COLORADO
Division of Reclamation,
Mining and Safety
Department of Natural Resources

**Re: Brannan Sand and Gravel Company, L.L.C.; Valley's Edge Resource;
File No. M-2016-030; 112c Permit Application Second Adequacy Review**

Enclosure – Galena Slope Stability Verification Analysis

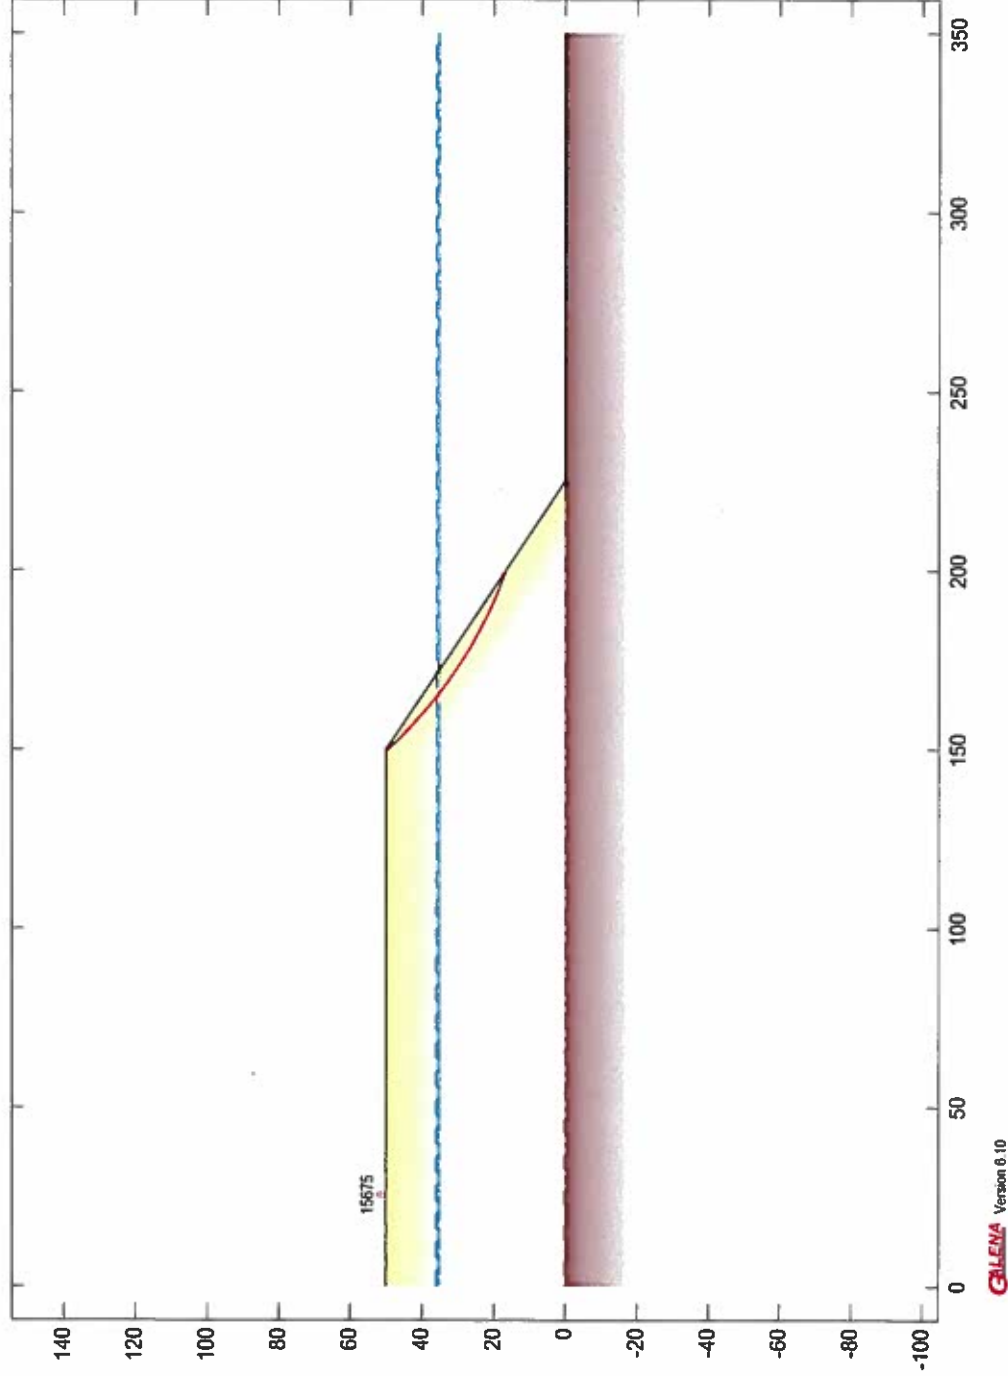
7. The Division's engineering staff reviewed the slope stability analysis from Applegate Group, Inc. dated November 8, 2016. The Division duplicated the analysis with Clover Technology's Galena software for verification purposes. The factor of safety produced by Galena (1.32) is lower than the factor of safety produced by the Applicant's calculation (1.35). However, the factor of safety is greater than the required factor of safety of 1.3. Therefore, the accuracy of the Applicant's analysis is confirmed. A copy of the Galena model is attached.
